PIM No: *BCon21/0063*

Project Location	TO BOOK AN INSPECTION PLEASE PHONE WDC BUILDING CONTROL	BCon21/0063
31 Halswell St WHANGANUI	ON 349 0001 AND QUOTE THE FOLLOWING APPLICATION NUMBER:	
Description of Work	Additions & Alterations to the Existing Dwelling (21m2).	
Applicant	Mr PE Clark 65D Portal Street, Durie Hill, Whanganui 4500

The building consent application is currently being assessed. Please supply the answers to the questions below in a specific covering letter clearly cross-referencing our questions and ensure that the altered drawings are also cross-referenced and have appropriate 'clouding' or highlighting etc. to clearly identify changes. All RBW questions **MUST** be addressed by the LBP responsible for the design and confirmation supplied. Please ensure that you quote this Project Number BCon21/0063 on all changes made to the documents.

ALTERED FLOOR PLAN 1:100

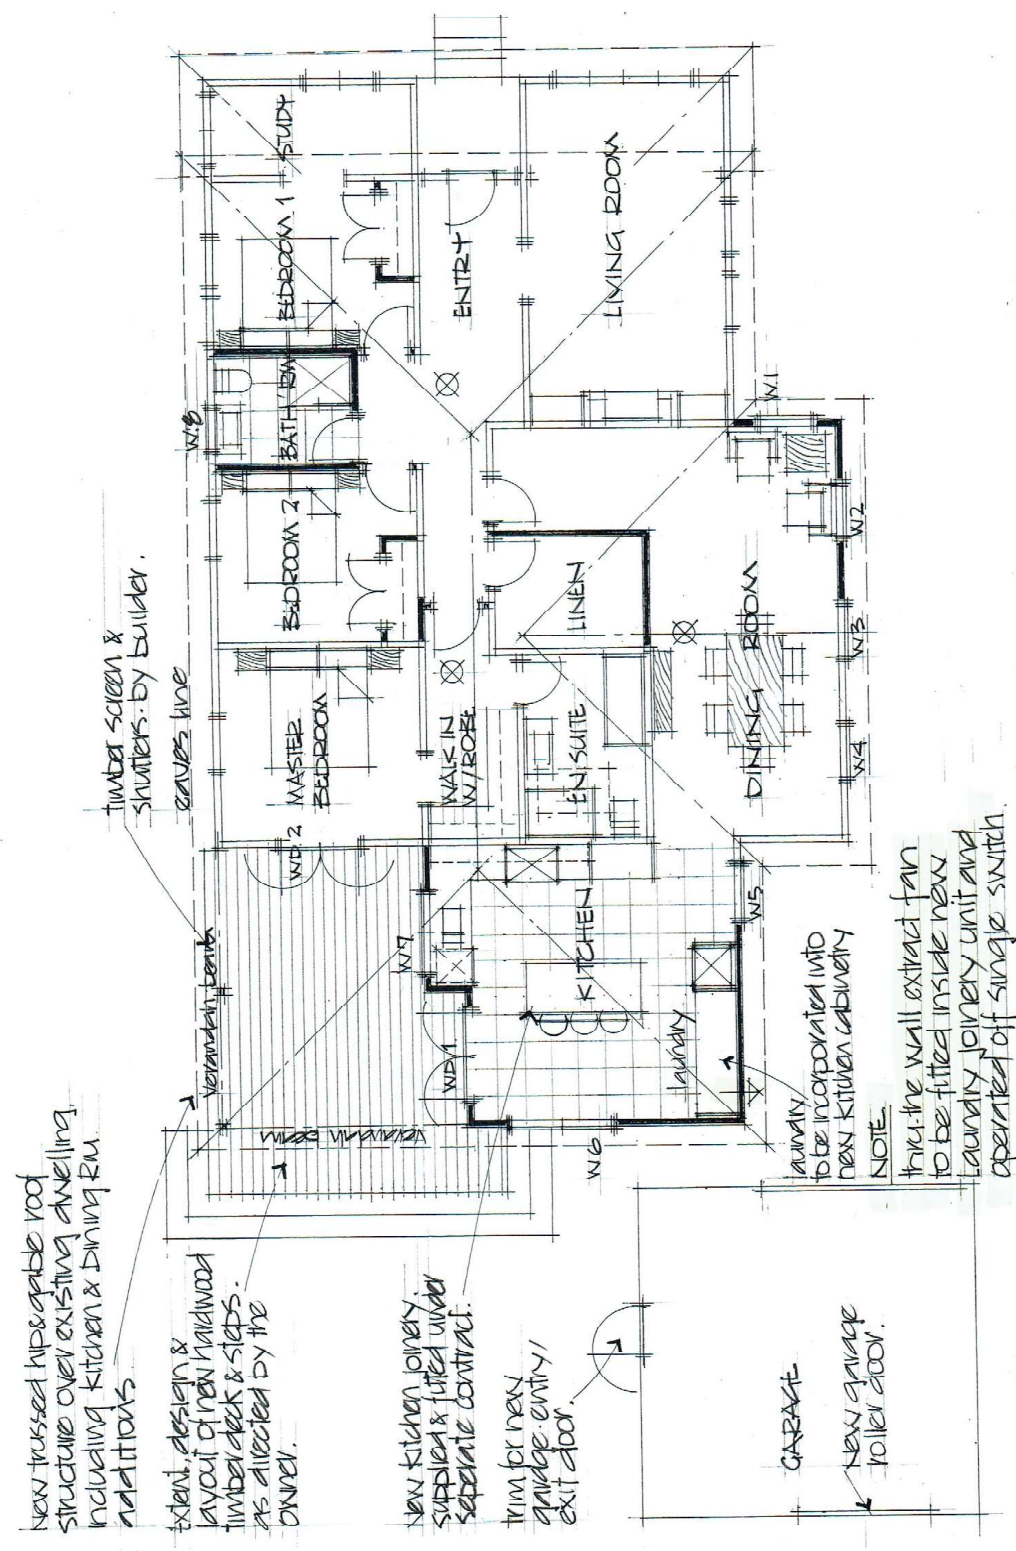
3. Please address mechanical ventilation to the laundry and hob. (Ben Nyssen - Building Control)
4. Please provide a threshold junction detail for the deck to dwelling. (Ben Nyssen - Building Control)

- New laundry joinery unit to be fitted with thru-the wall extract fan c/w wall switch.
- Extract hood is to be fitted over kitchen cooking hob & vented thru roof above - Model *Schweigen um 1170-94p
- 40 cm Power Pick Rangehood c/w powerful external motor. Refer installation details.
